TECH TALK

Volume 232 - July 2017

NEW DOOR WINDOW BOLTS — 2014–17 Mirage, 2017 Mirage G4.

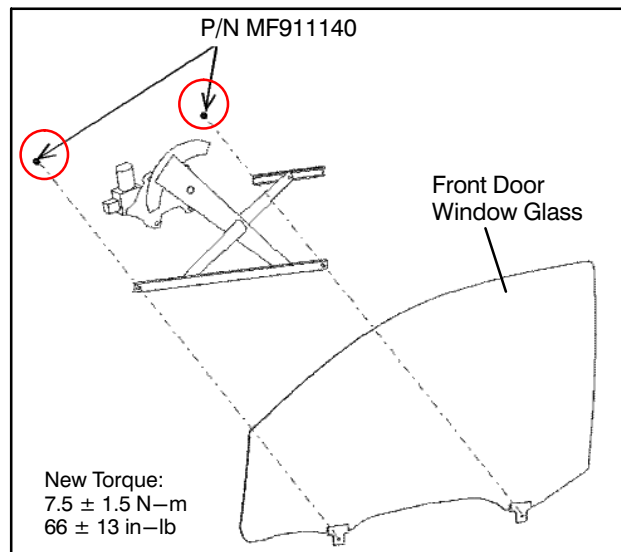
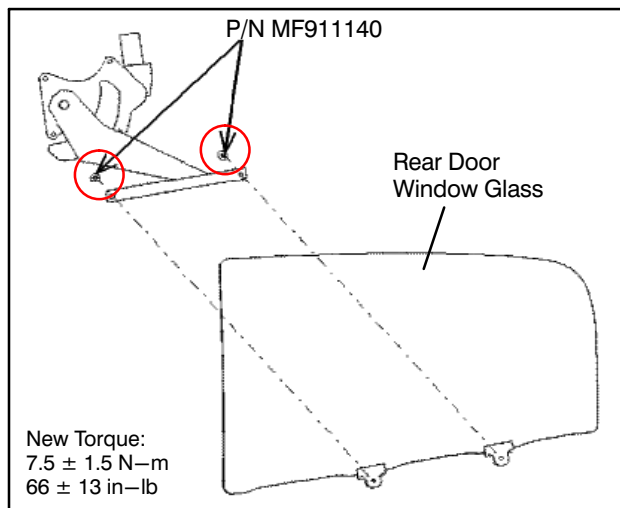
When replacing a door window regulator, or servicing a vehicle with loose door window bolts, be sure to replace the existing bolts with the newly specified flange type bolts. These bolts are available as service parts, P/N MF911140, and can be used on both the front and rear doors.

Be sure to use the new tightening torque specification with the new bolts (see illustrations below).

- Old Bolt P/N: MU000401
Old Torque: 5.0 ± 1.0 N-m (44 ± 8 in-lb)
- NEW Bolt P/N: MF911140
NEW Torque: 7.5 ± 1.5 N-m (66 ± 13 in-lb)
